Access Compliance Report

Public Rights-of-Way

Intersection ID: 18294	Main Street: E_WOODLAWN_RD	Cross Street: MONTFORD_DR	Location: W
ADA ID: C24730EB8645	Ramp Type: PerpDiag	Initial Pass/Fail: Fail	Overall Compliance: No
			Severity Score: 21.25

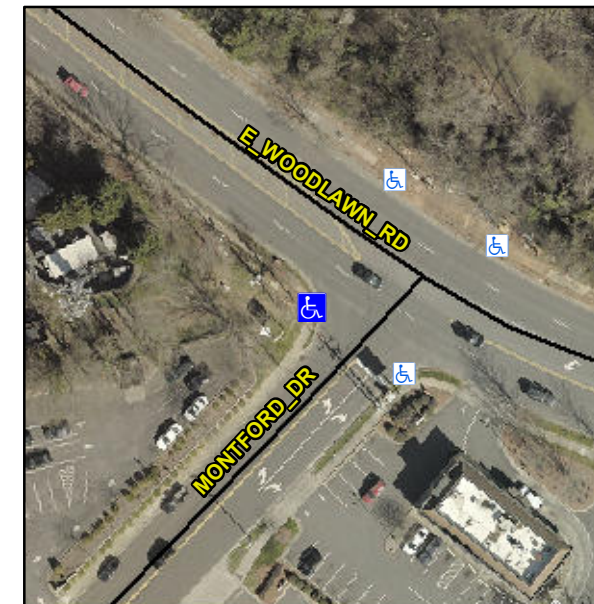
Not Found, R304.5.1, R304.2.2

Compliance	Description	Data	Compliance	Description	Data
N/A	Ramp Length (in)	57.0	No	Ramp Slope (%)	9.8
No	Ramp Width (in)	43.0	Yes	Ramp XSlope (%)	0.6
N/A	Flare Type LT	N/A	N/A	Flare Type RT	N/A
N/A	Flare Slope LT (%)	N/A	N/A	Flare Slope RT (%)	N/A
N/A	Flare Traversable LT?	N/A	N/A	Flare Traversable RT?	N/A
N/A	Landing Length (in)	N/A	N/A	DWS Provided?	N/A
N/A	Landing Width (in)	N/A	N/A	DWS Contrast?	N/A
N/A	Landing Slope (%)	N/A	N/A	DWS Length (in)	N/A
N/A	Landing X Slope (%)	N/A	N/A	DWS Full Width?	N/A
N/A	Landing Curb? (Y/N)	N/A	N/A	DWS Offset (in)	N/A
N/A	Shared Landing?	N/A			
N/A	Gutter Ponding?	N/A	N/A	Gutter Slope (%)	N/A
N/A	Gutter Lip Ht (in)	N/A	N/A	Gutter X Slope (%)	N/A
N/A	Painted X Walk1?	No	N/A	Painted X Walk2?	No
	X Walk 1 Direction	To SE		X Walk 2 Direction	To NE
N/A	X Walk 1 Width (in)	N/A	N/A	X Walk 2 Width (in)	N/A
	X Walk 1 Slope (%)	1.4		X Walk 2 Slope (%)	1.4
	X Walk 1 X Slope (%)	1.9		X Walk 2 X Slope (%)	0.7

Remove & Replace Curb Ramp With Two New Directional Ramps or Equivalent.
